## Service Bulletin B787-81205-SB280015-00 FUEL - Fuel Distribution - Fuel Shutoff Valve Actuator Test and Replacement

| Publication: | B787-81205-SB280015-00 | Issue 002, 19 Jun 2014 |

1. Change the compliance time for the terminating action from 60 months to 36 months.
2. Include the reference to the Eaton service bulletin 53-0037-28-01.
3. Include a note in the General Information section to inform operators that the external power is required for the PART 2 : APU FUEL SHUTOFF VALVE ACTUATOR TEST.
4. Clarify the engine and APU fuel shutoff valve actuator test procedures.

Figure 1

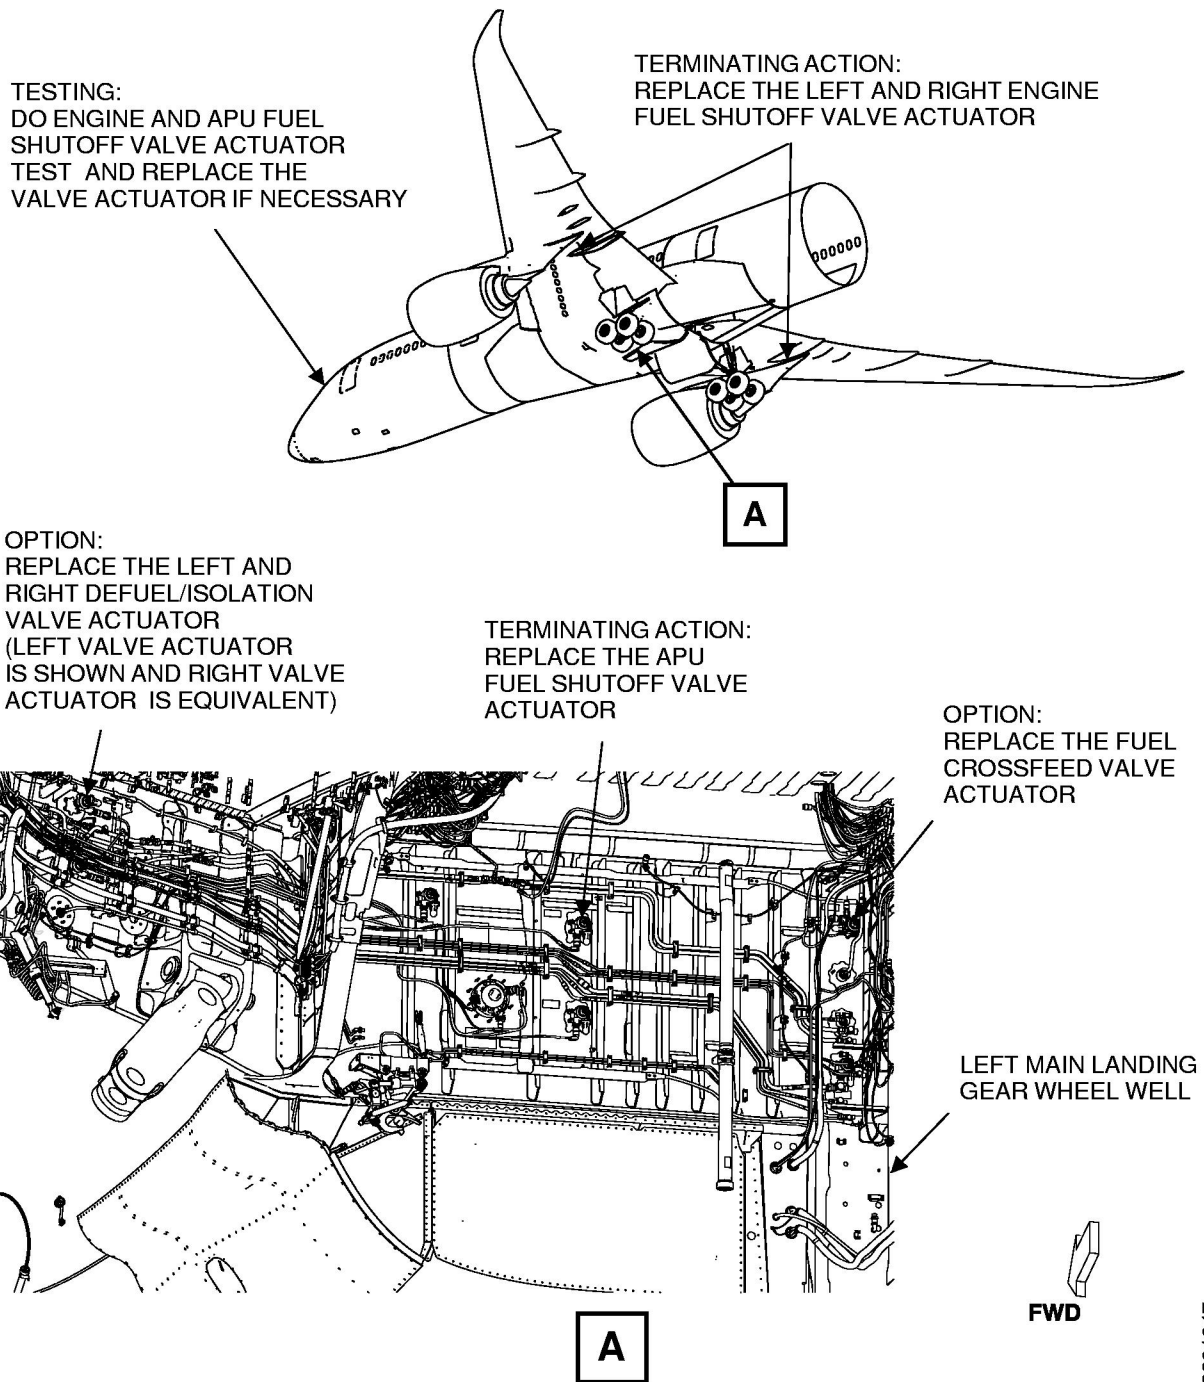
This service bulletin gives instructions to test the engine and Auxiliary Power Unit (APU) fuel shutoff valve actuators to make sure that the valve operation and indication are working correctly. This service bulletin also provides the terminating action to replace the engine and APU fuel shutoff valve actuators and an option to replace the fuel crossfeed and defuel/isolation valve actuators. Incorporation of this service bulletin prevents possible operational disruptions.

The fuel shutoff valve actuator circuit design provides common input power through micro-switches to both the motor and position indication. It was identified that the valve actuator circuitry has a potential latent failure condition previously not identified during its development. The latent failure condition is with respect to the potential for a stuck micro-switch which could lead to a disagreement between the valve command and position indication. In a case where a command is sent to change valve position and one of the internal micro-switches is stuck in the depressed state, power would immediately provide indication that the valve transitioned to its commanded state when in reality the motor never received power to rotate. Changes were made to the actuator micro-switch circuit by the supplier to provide independence between the valve command and indication functions which prevent the latent failure condition. Refer to Fleet Team Digest 787-FTD-28-13002 for additional information.

Testing: Do the engine and APU fuel shutoff valve actuator test and replace the valve actuator if necessary.

Terminating Action: Replace the engine and APU fuel shutoff valve actuators.

Option: Replace the fuel crossfeed and defuel/isolation valve actuators.
